# Feasibility Study for Castle Peak Road Improvements

between Ka Loon Tsuen and Yau Kom Tau

**ENVIRONMENTAL IMPACT ASSESSMENT**

Report No. 97294/R38

Figure 2.1 Sensitive Receivers: Ka Loon Tsuen

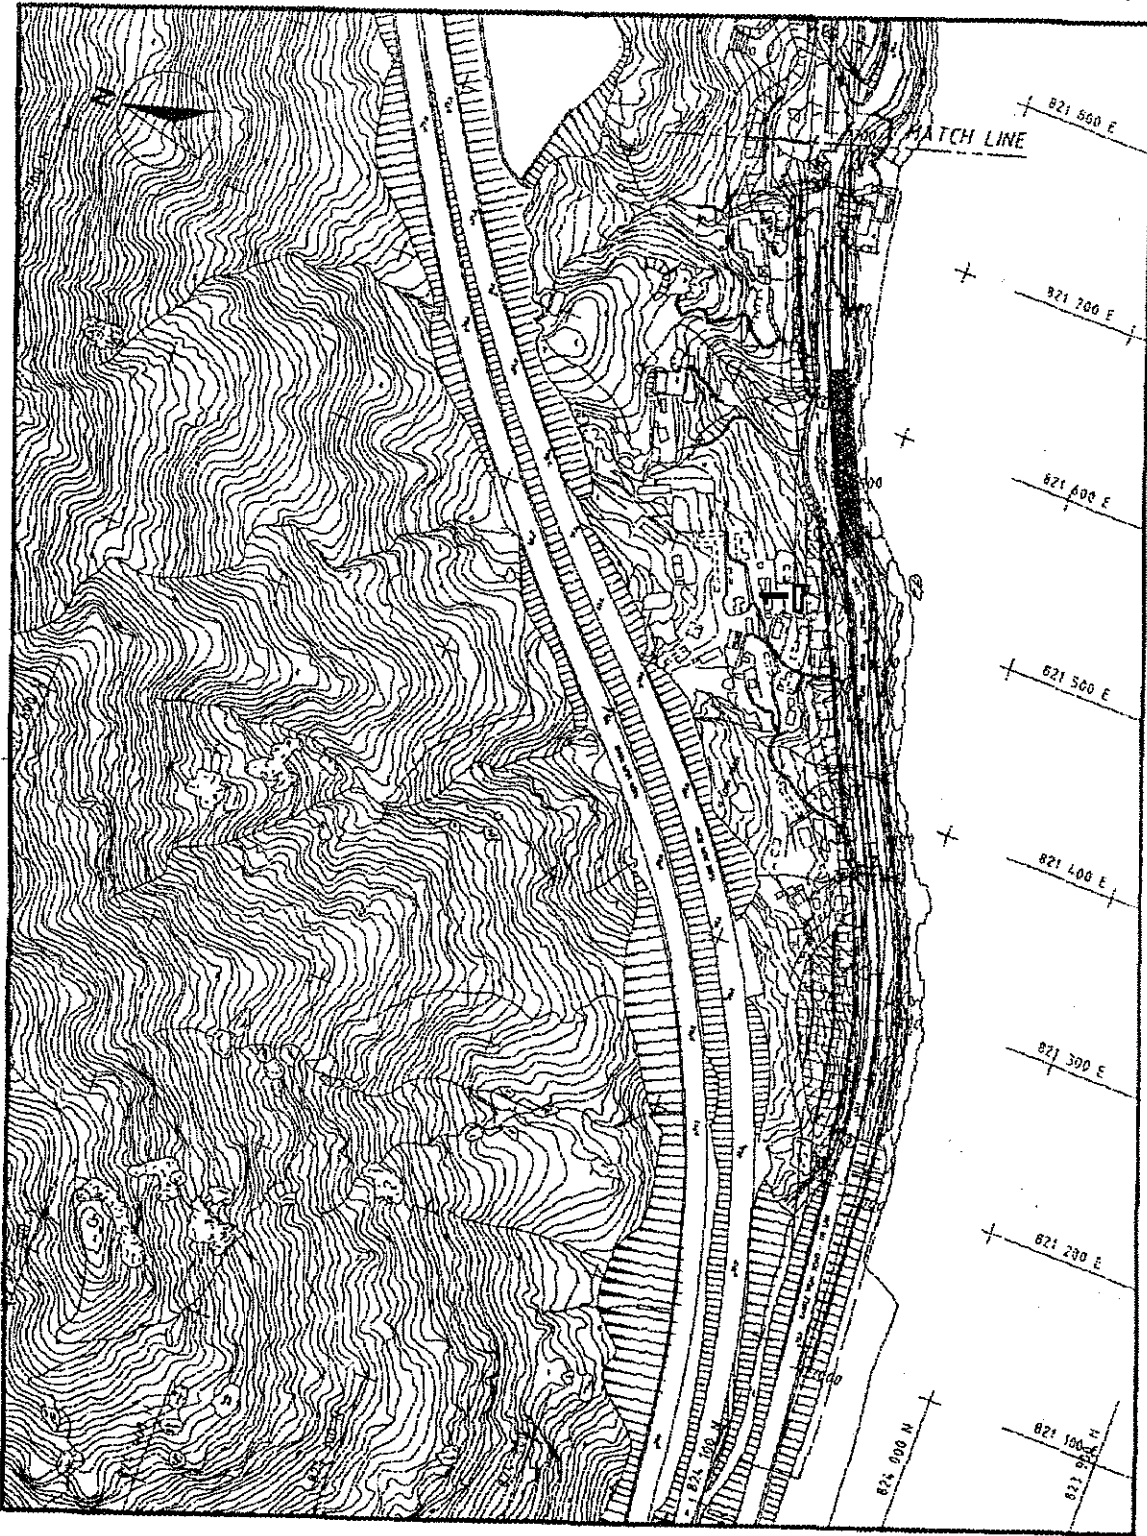
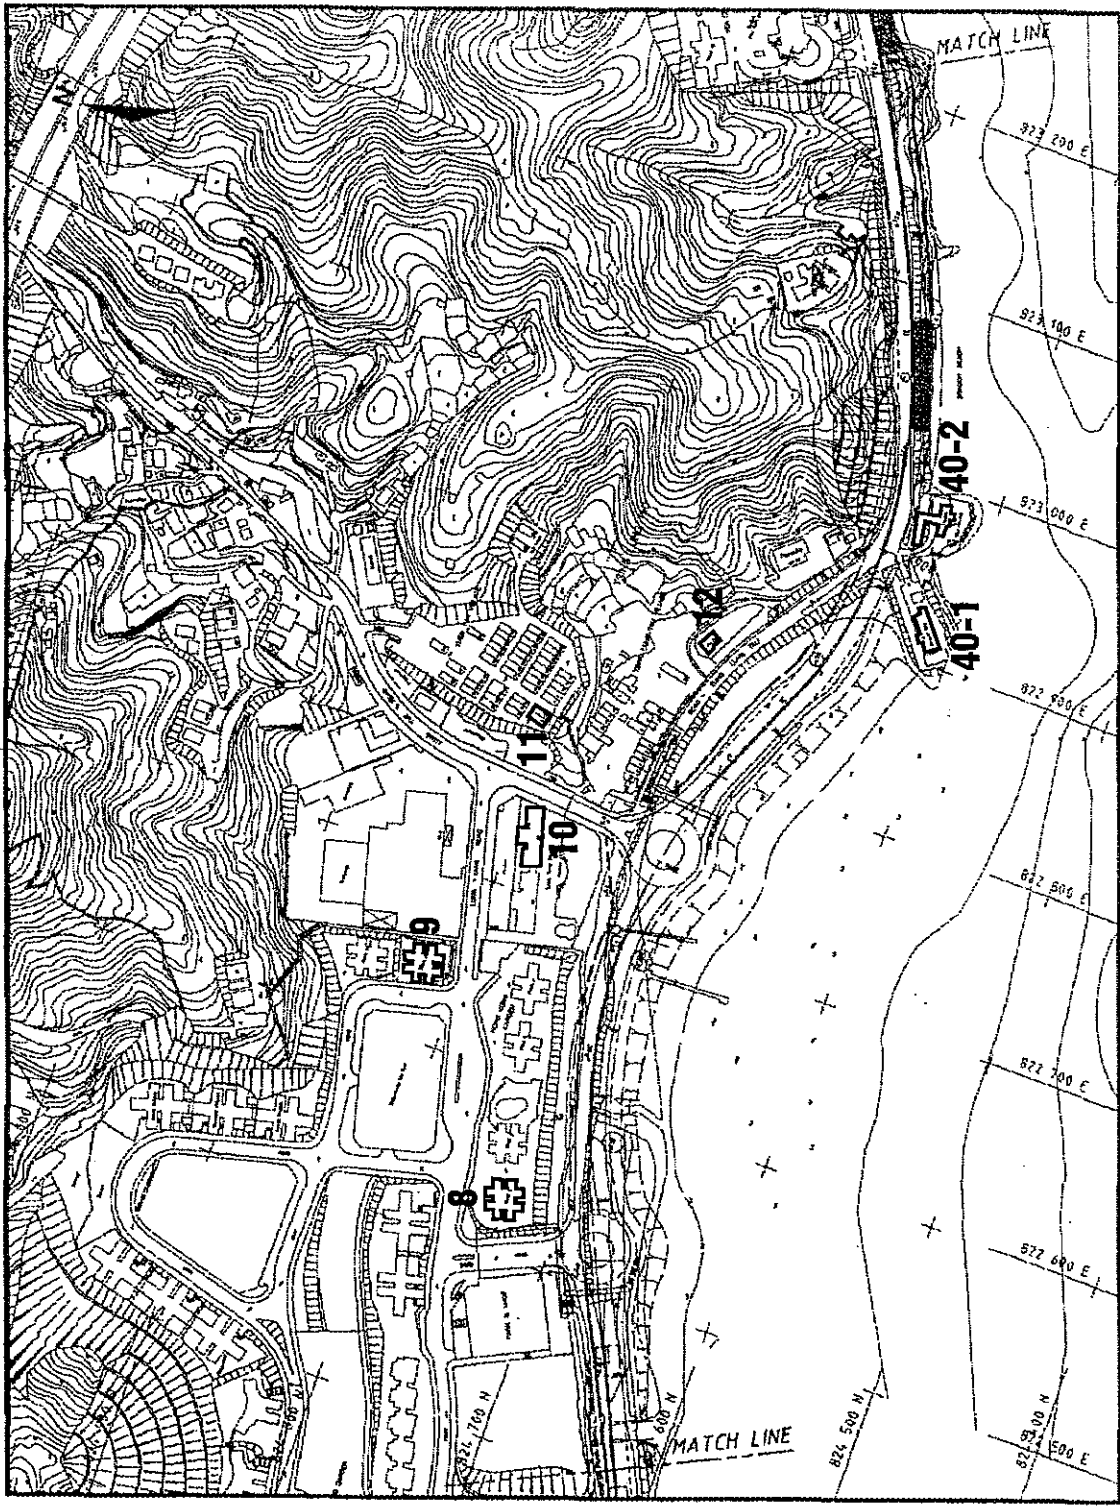
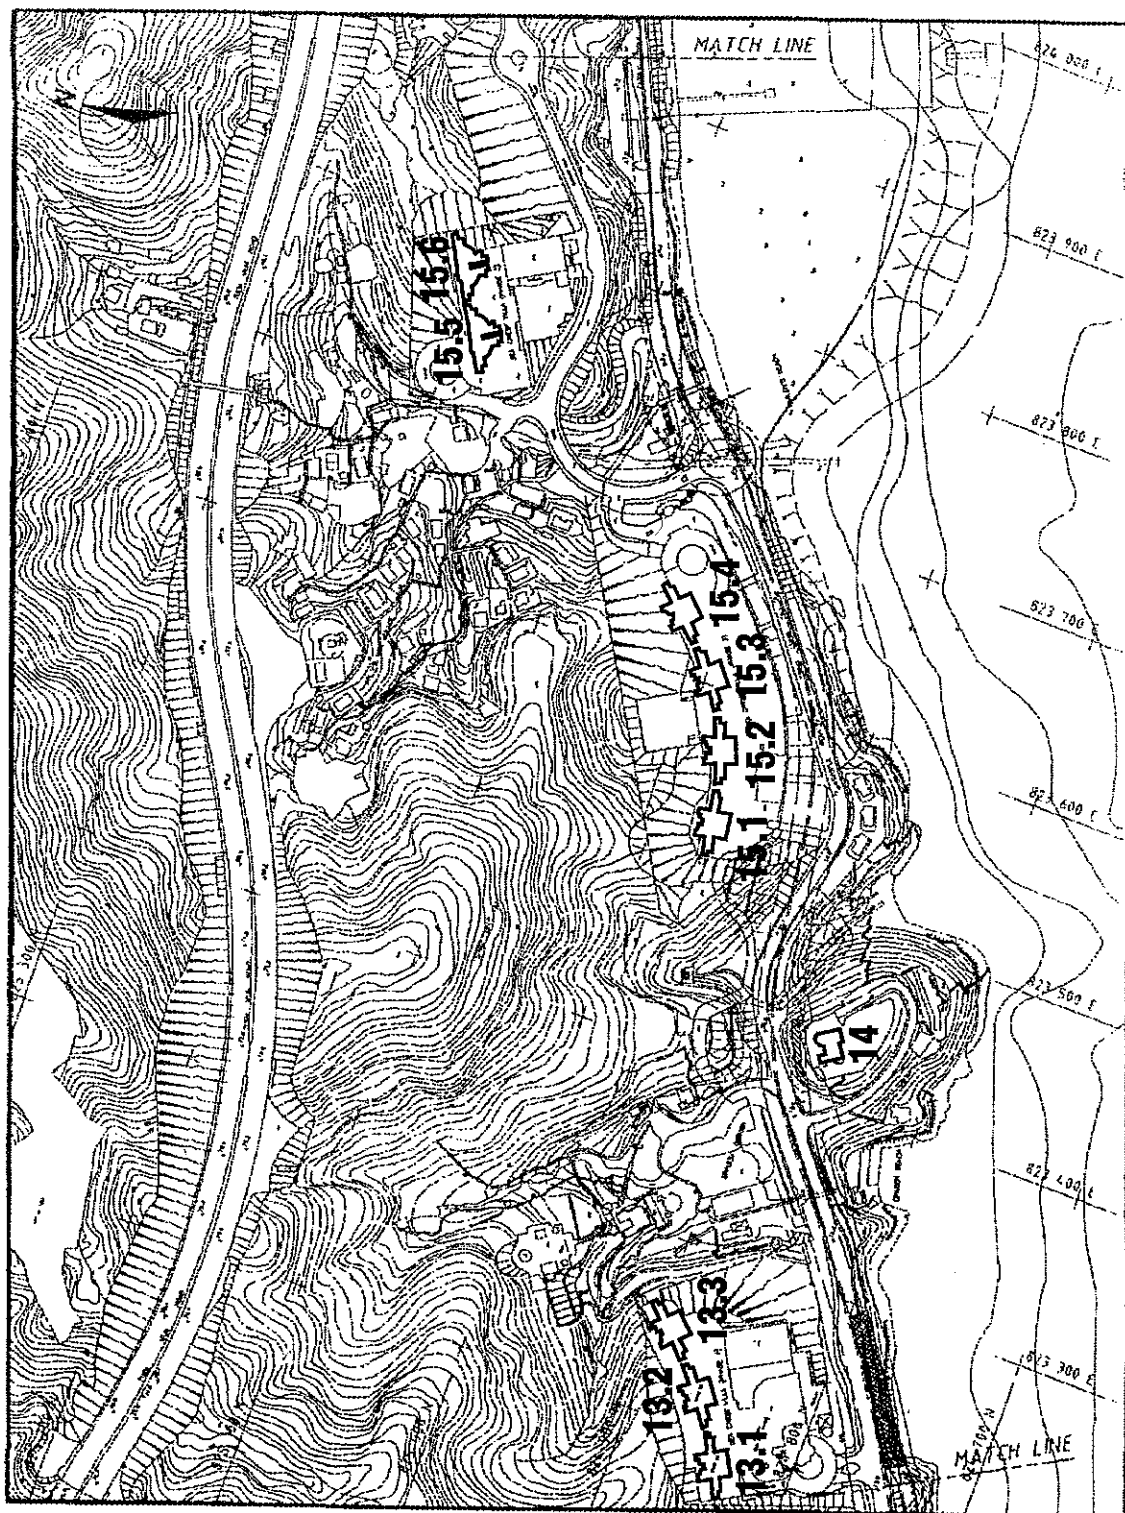
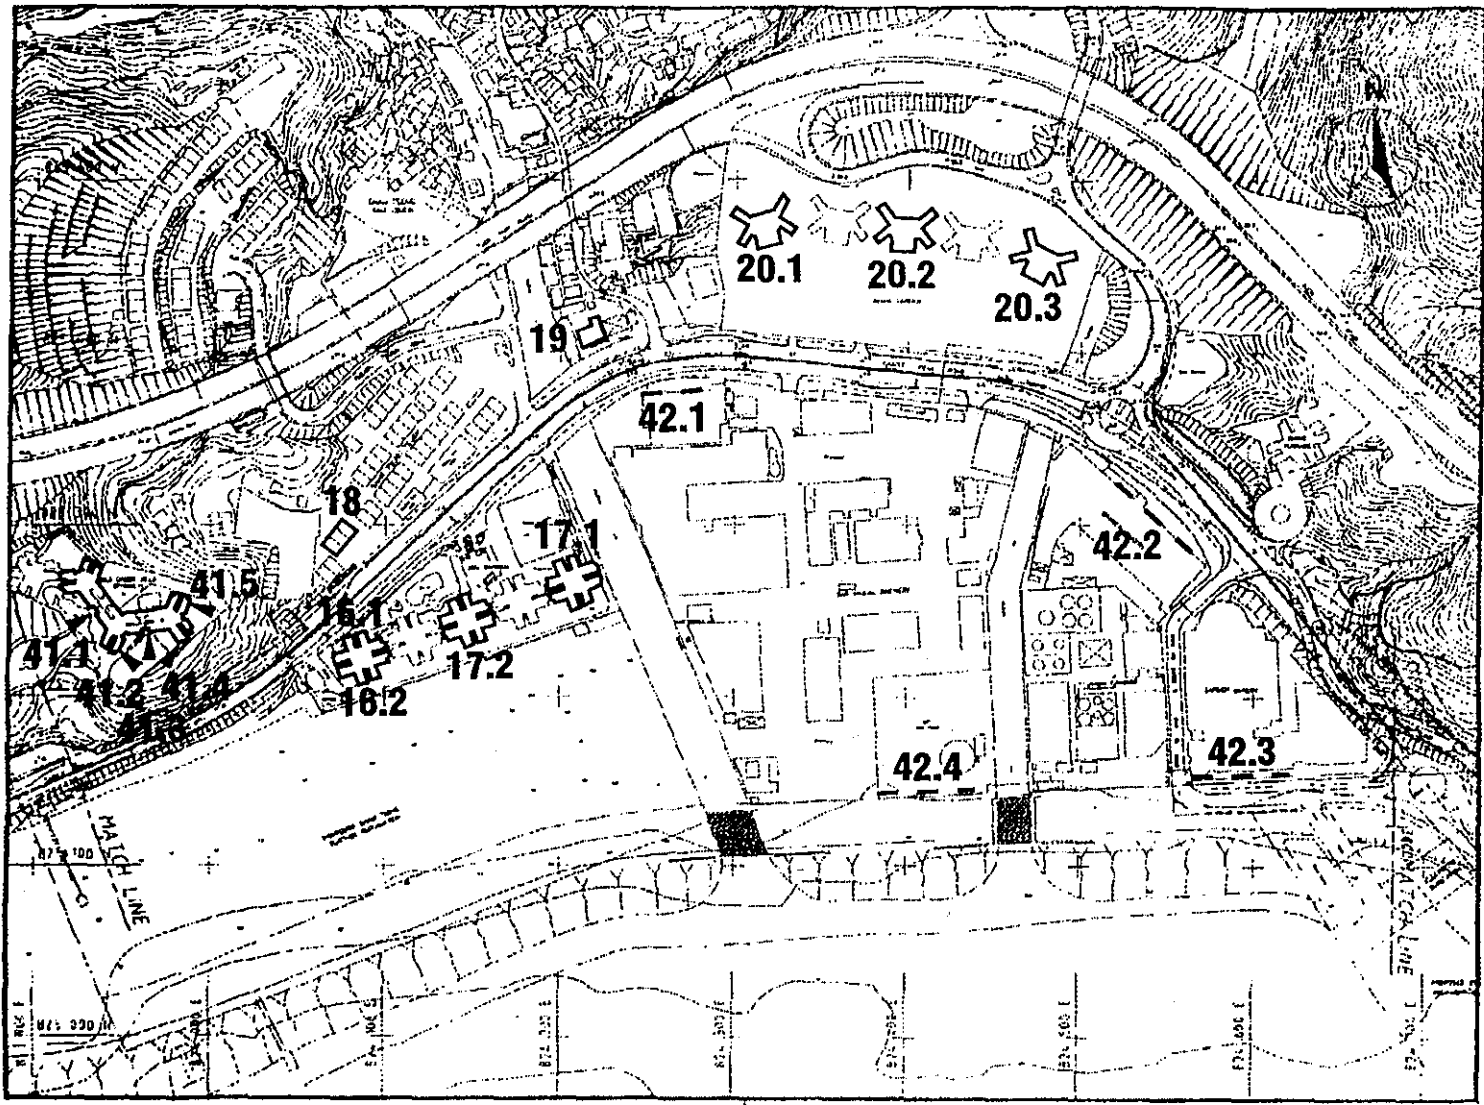
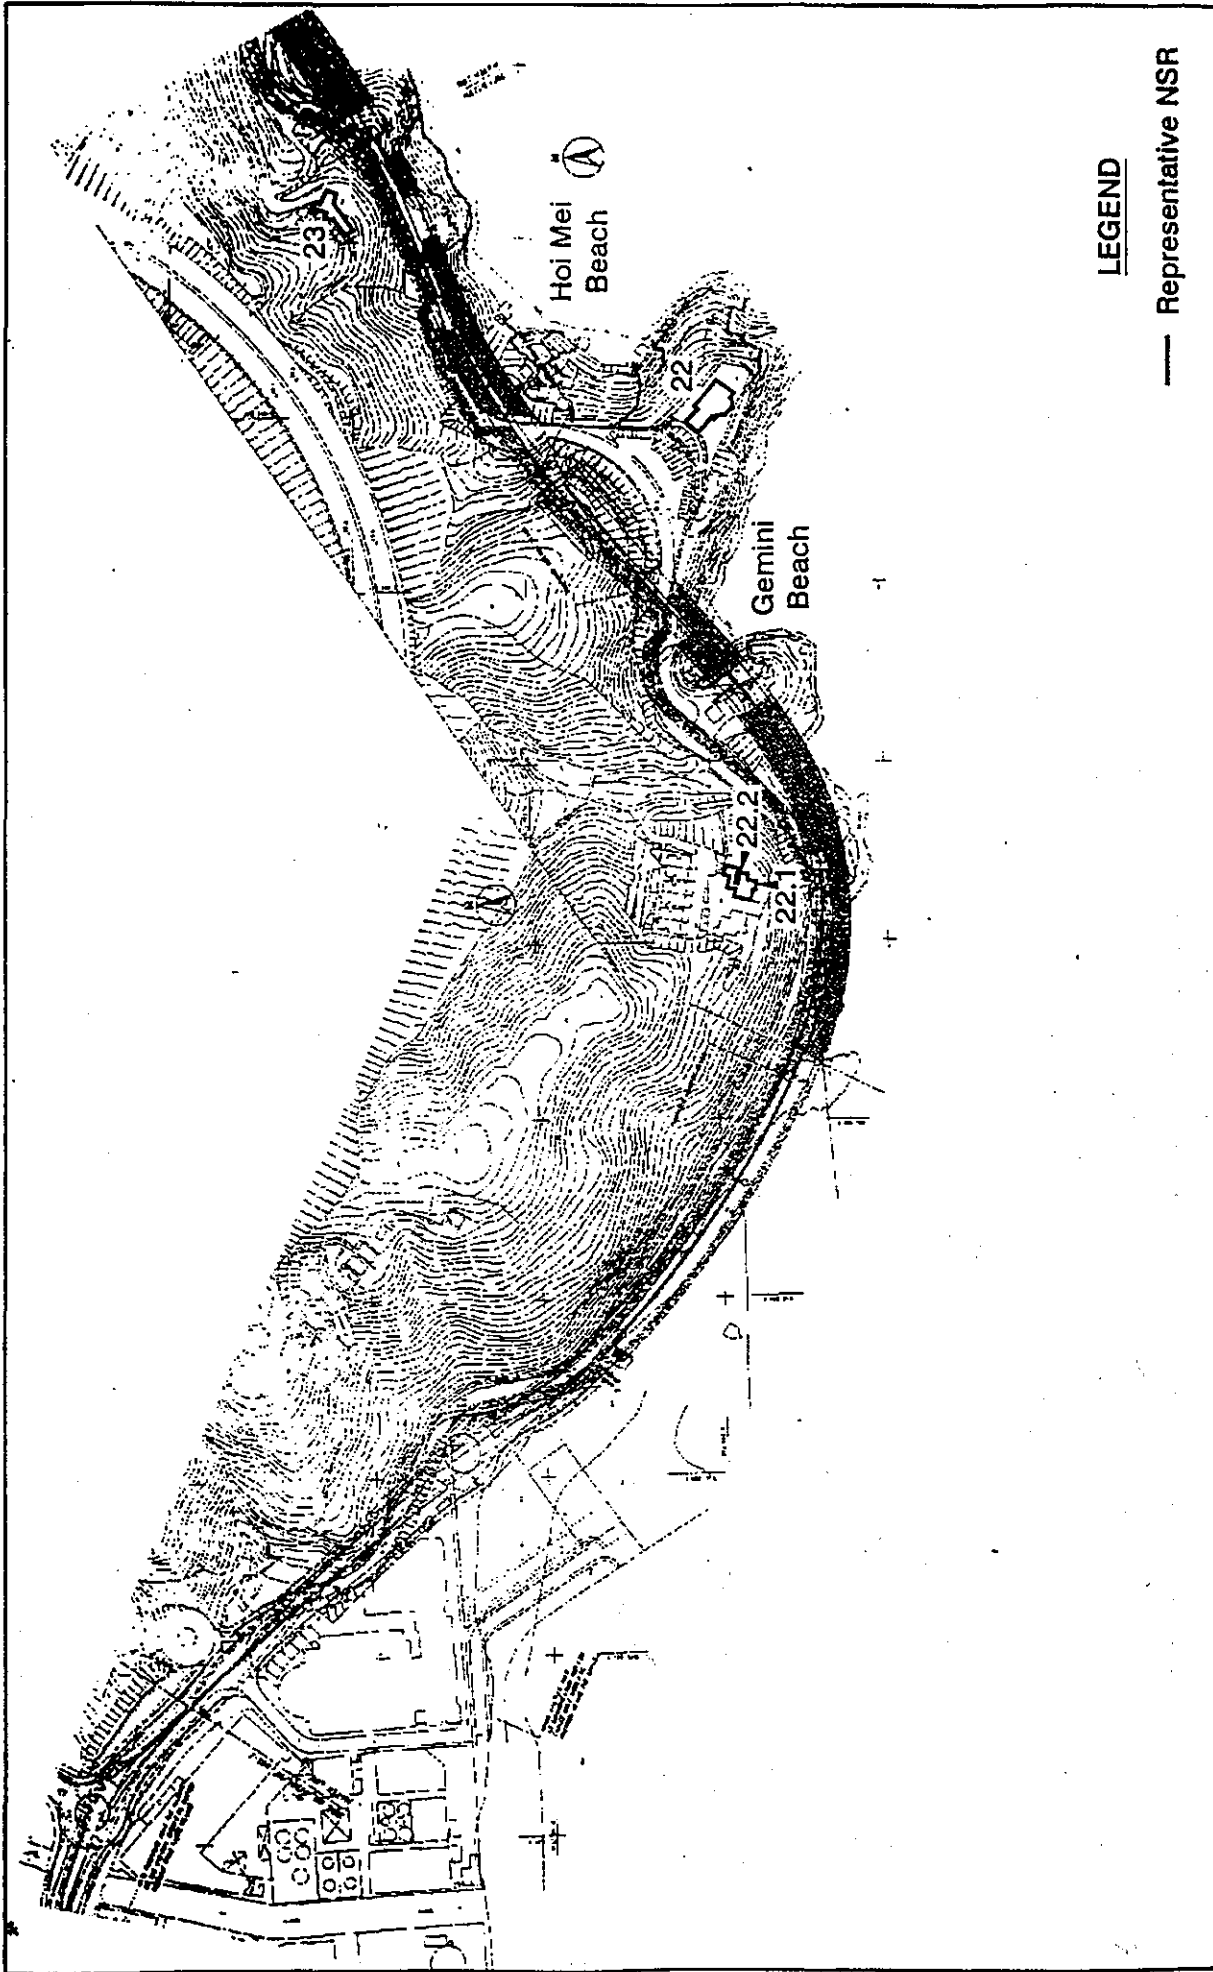
| (ii)   | Fig 2.1 to Fig 2.10, titles of these drawings do not correspond to the intended uses. Two sets of numbers, 97294 and Fig 2.1 (sketch) are presented and are confusing. Would you please revise the title and drawing number of this set of drawings.   | Rough sketches of Figures 2.1 to 2.10 were provided in the Preliminary Draft EIA as the final versions of these Figures were not yet available. Final versions of these Figures are now complete and will be presented in the Draft EIA. |
